Product Change Notice (PCN)

PCN Number: PCN-0451089R-01

Product(s) Affected: *PJ-041-SMT-TR*

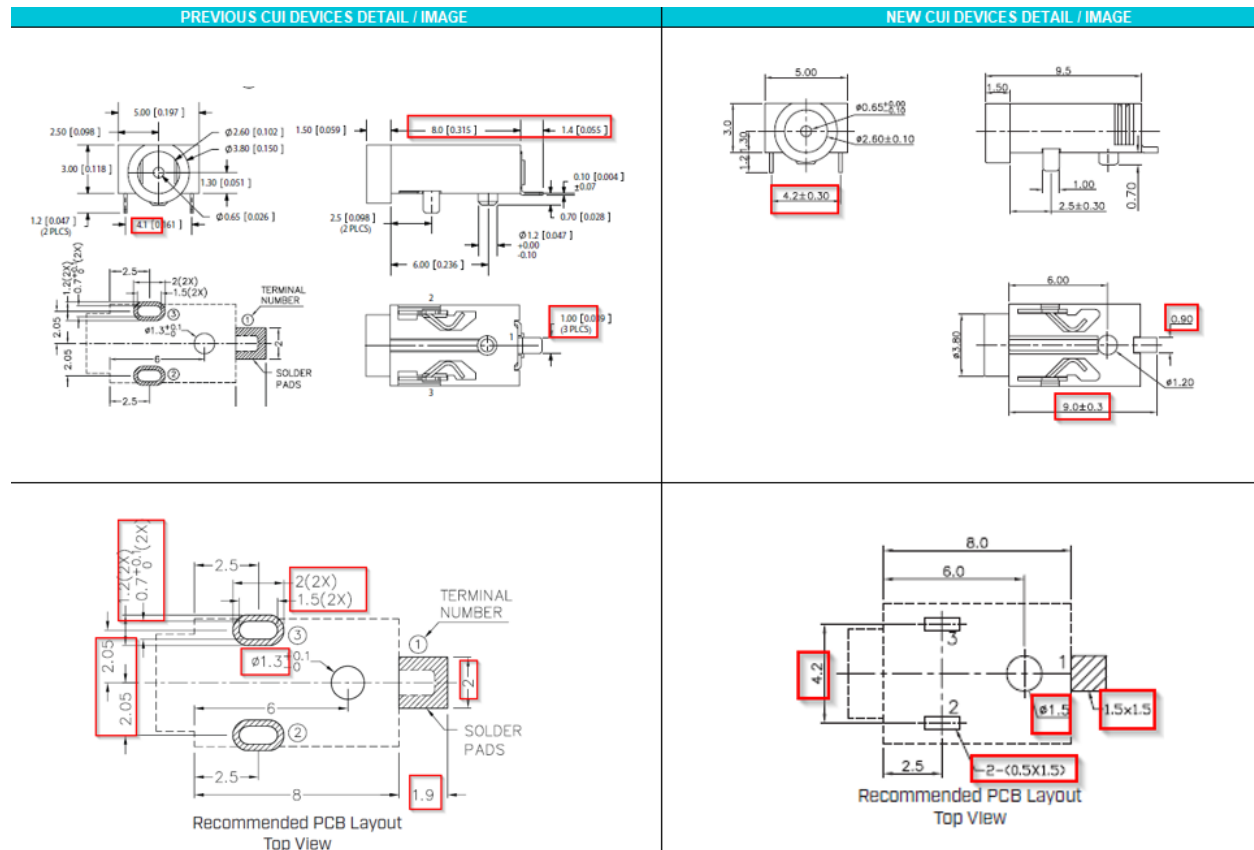
Description of Change: *Minor Housing and footprint differences. Material Change on the housing and terminals. PCB pad sizes, spacings differ. New part will fit on previous footprint. See image Below*

PREVIOUS CUI DEVICES DETAIL / IMAGE			NEW CUI DEVICES DETAIL / IMAGE		
	MATERIAL	PLATING		DESCRIPTION	PLATING/COLOR
center pin	copper	nickel		center pin	bronze silver
terminal 1	brass	silver		terminal 1	bronze silver
terminal 2	copper alloy	silver		terminal 2	SUS301 t=0.20 gold
terminal 3	copper alloy	silver		terminal 3	SUS301 t=0.20 gold
plastic	PAST or equivalent			housing	PA10T (UL94V-0) black
